ADDENDUM NO. 5

Rochester City School District

Dr. Walter Cooper, School #10

March 13th, 2018

AD5-E001

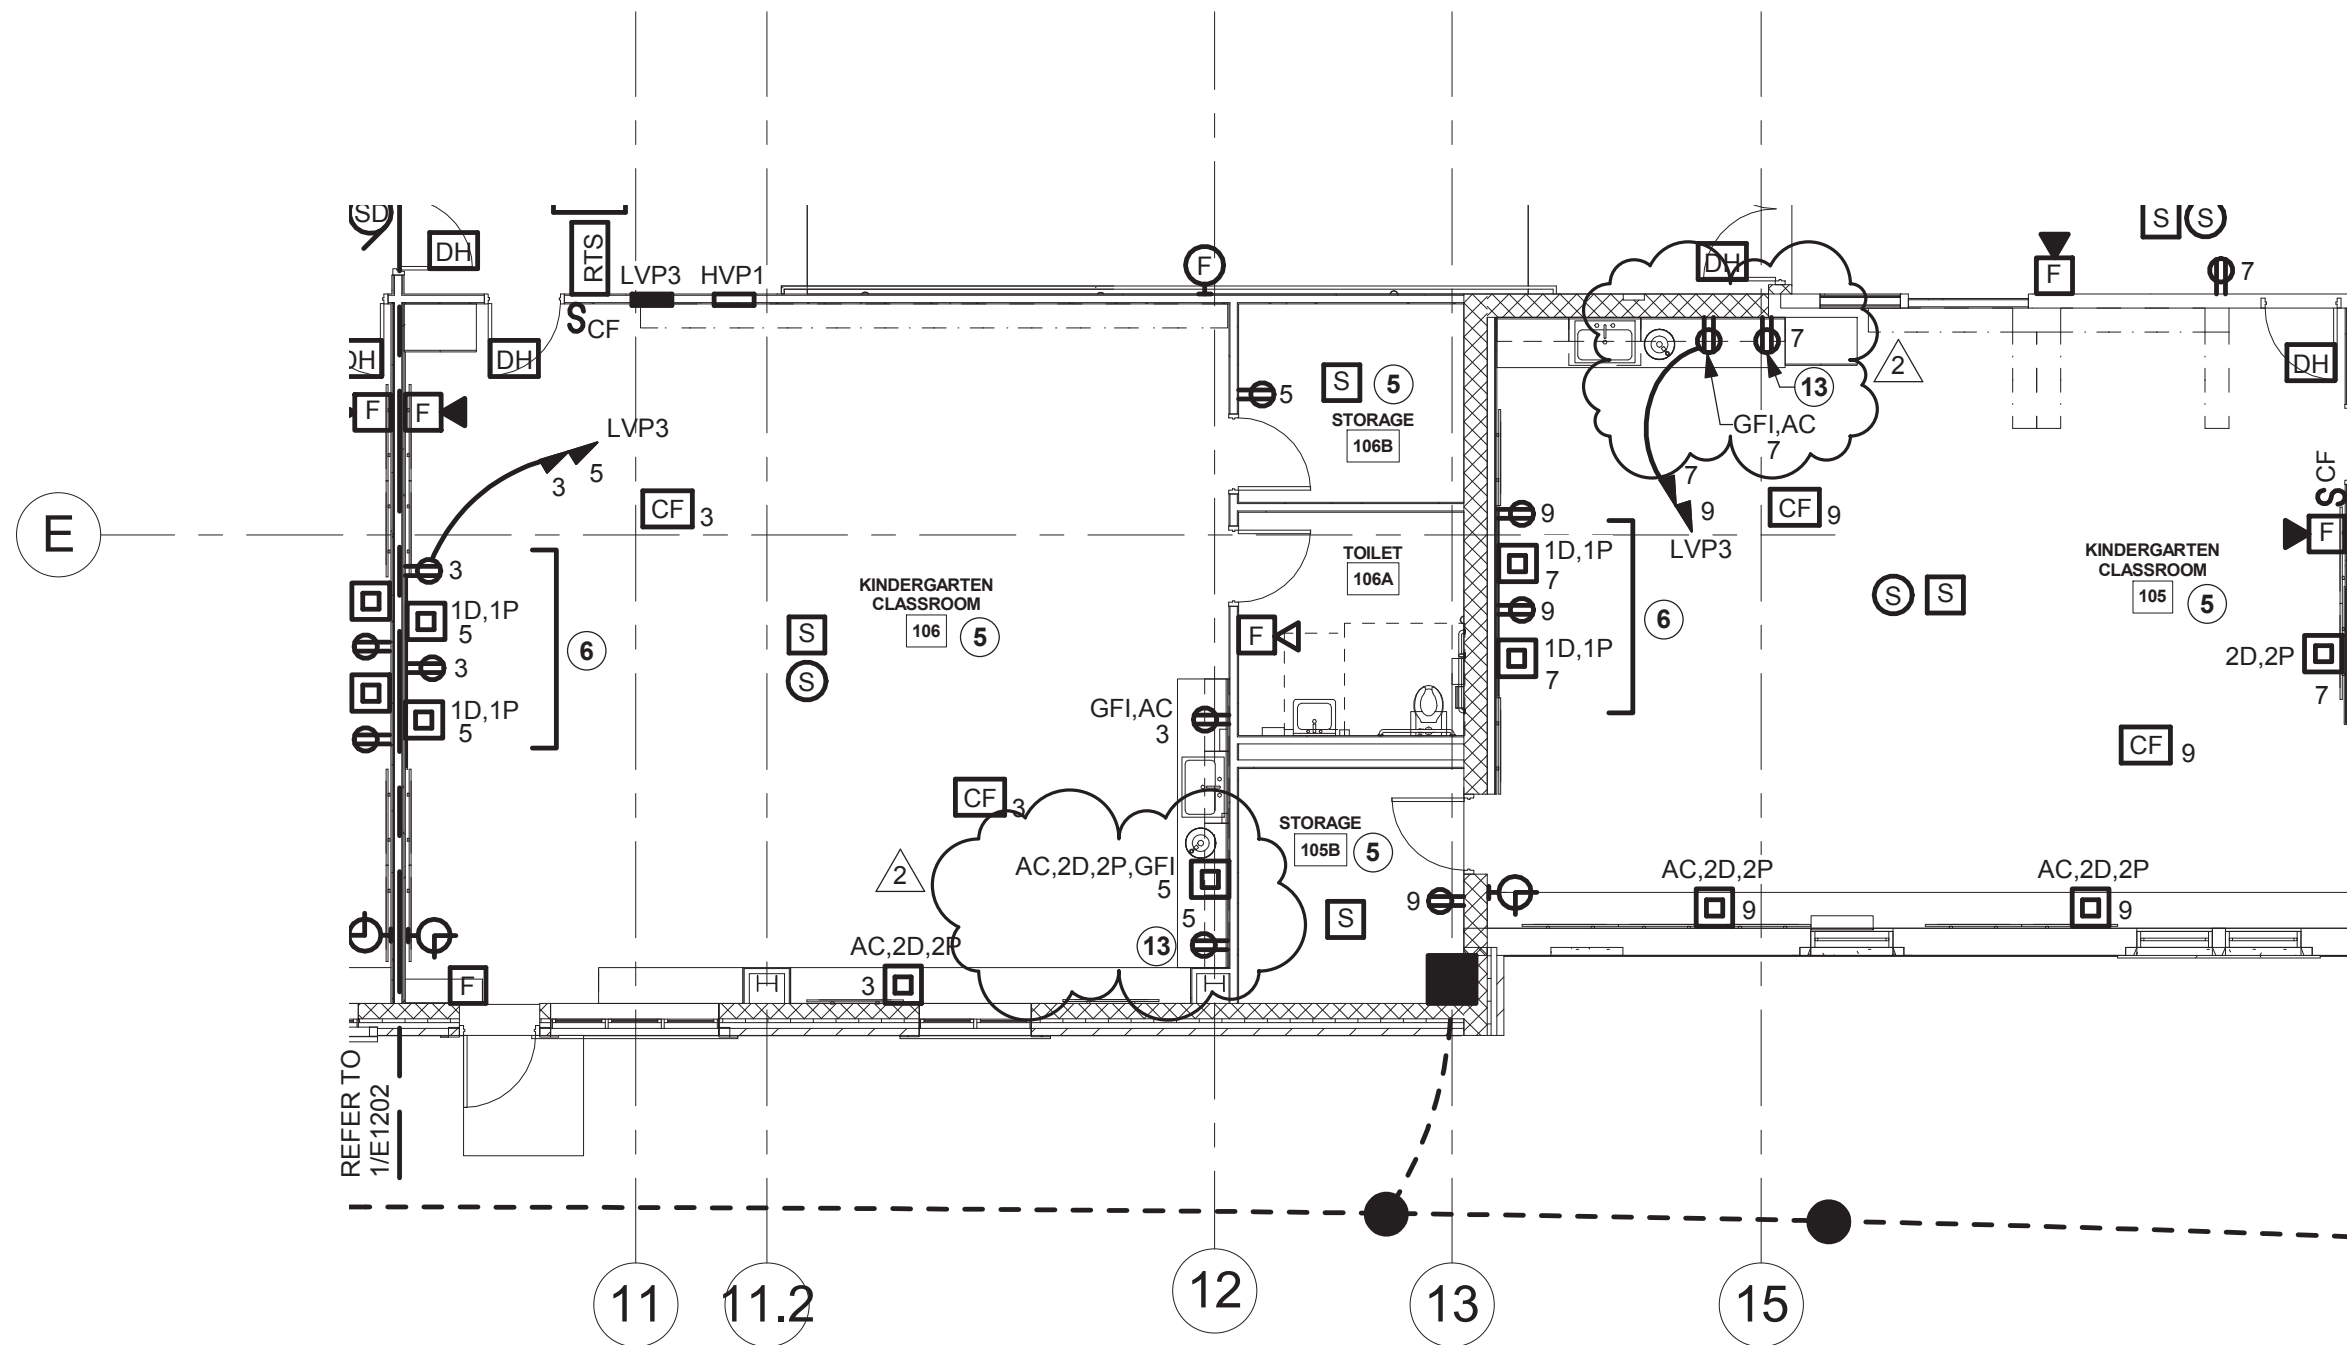
Item AD5-10 **REVISE** plan 1 PARTIAL FIRST FLOOR PLAN - POWER AND SS as detailed on AD5-E001 (Dated 03/12/18).

13 RECEPTACLE FOR UNDERCOUNTER FRIDGE. COORDINATE EXACT LOCATION IN THE FIELD.

AD5-E002

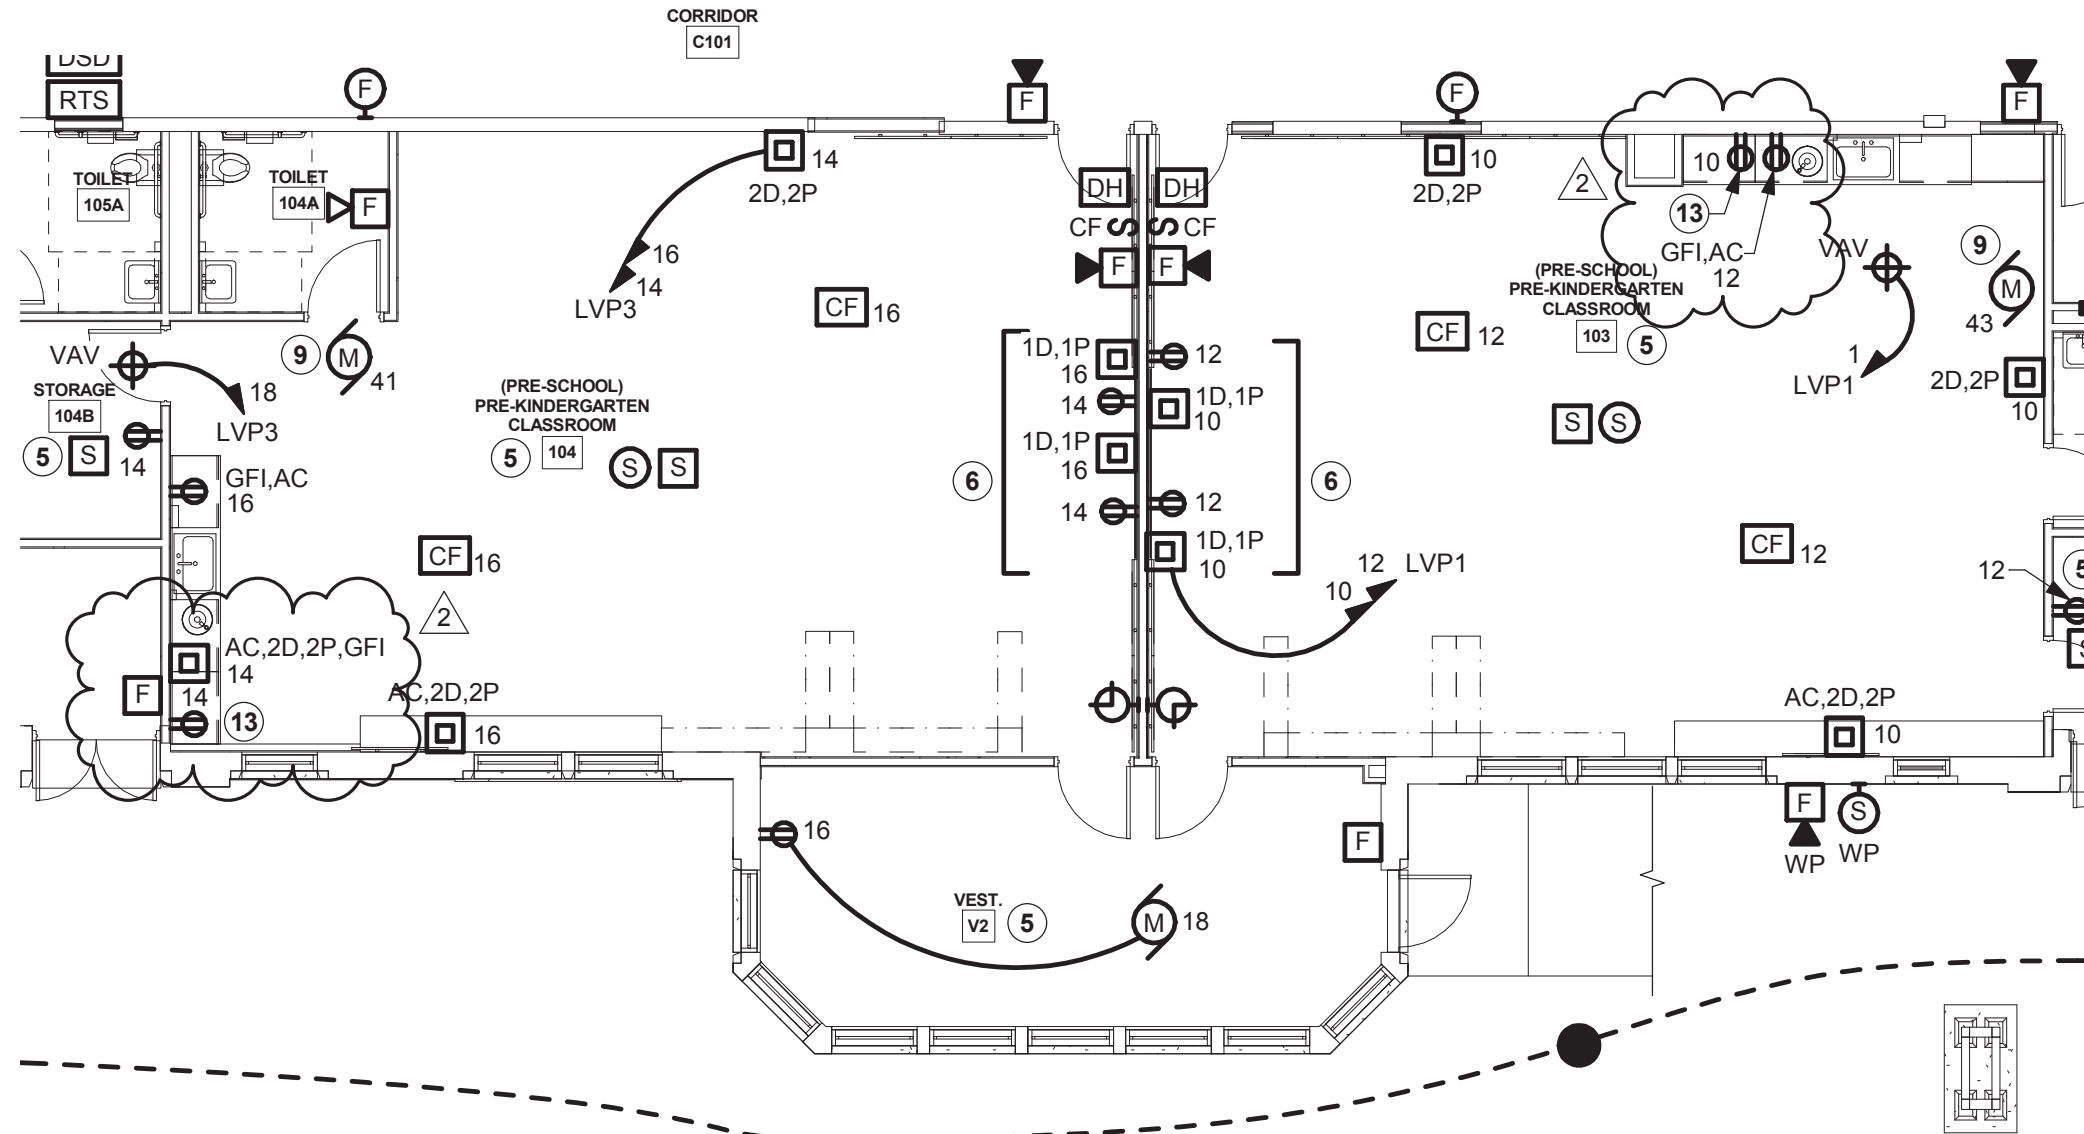
Item AD5-11 **REVISE** plan 1 PARTIAL FIRST FLOOR PLAN - POWER AND SS as detailed on AD5-E002 (Dated 03/12/18).

AD5-E003

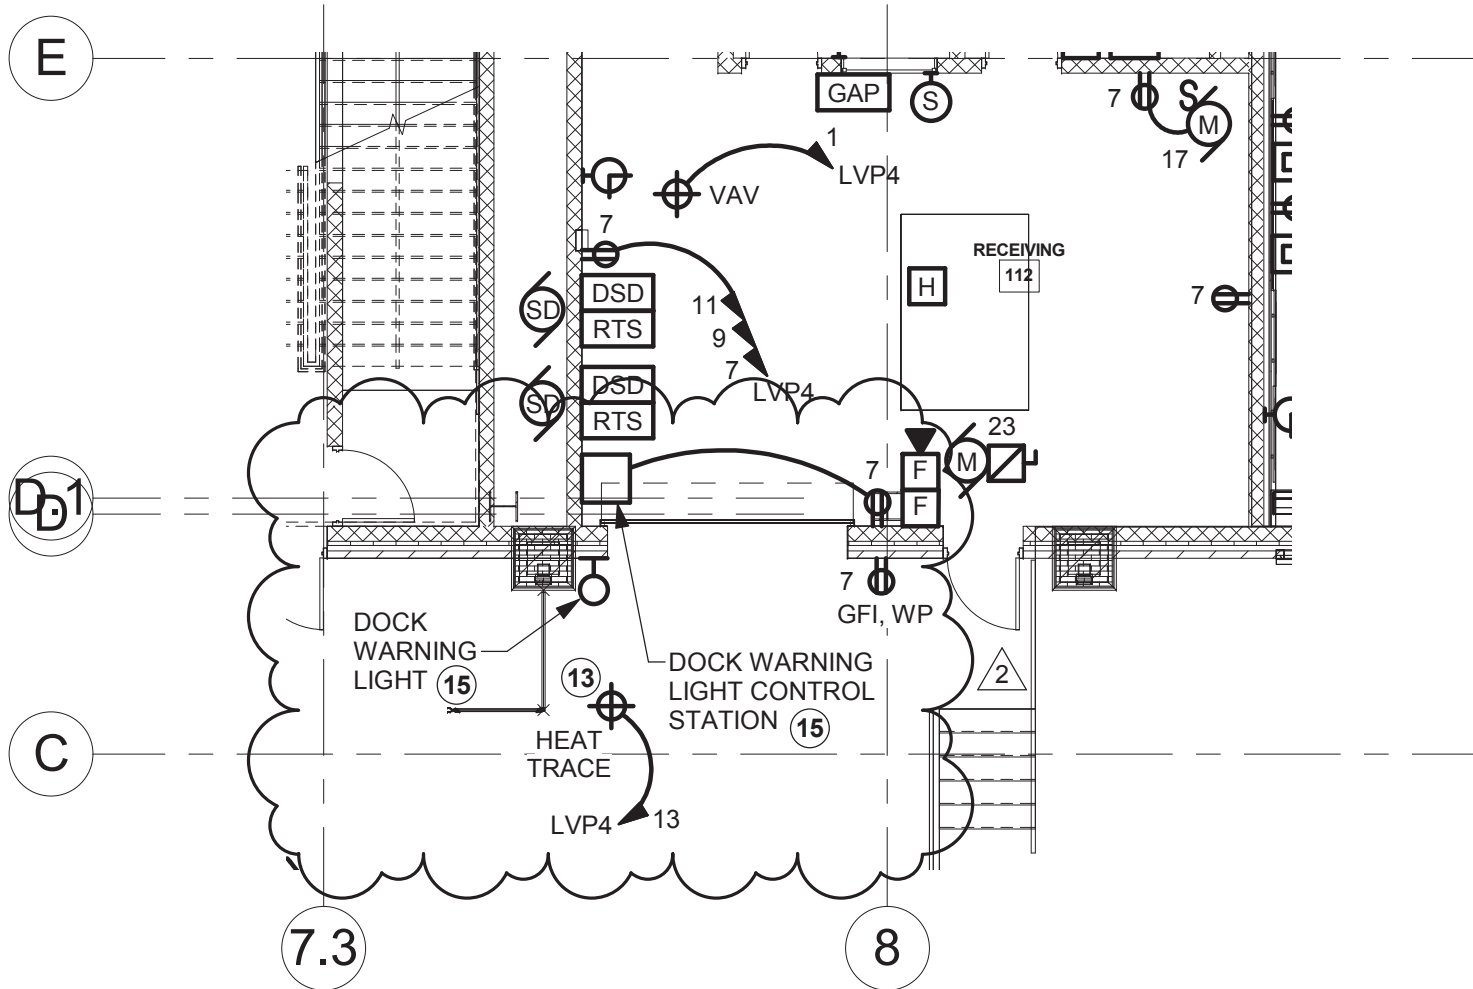
Item AD5-9 **REVISE** plan 1 PARTIAL FIRST FLOOR PLAN - POWER AND SS as detailed on AD5-E003 (Dated 03/12/18).

- 15 INSTALL EQUIPMENT FURNISHED BY OTHER TRADE PER MANUFACTURER'S INSTRUCTIONS. PROVIDE 3/4" C BETWEEN THE CONTROL STATION AND LIGHT.
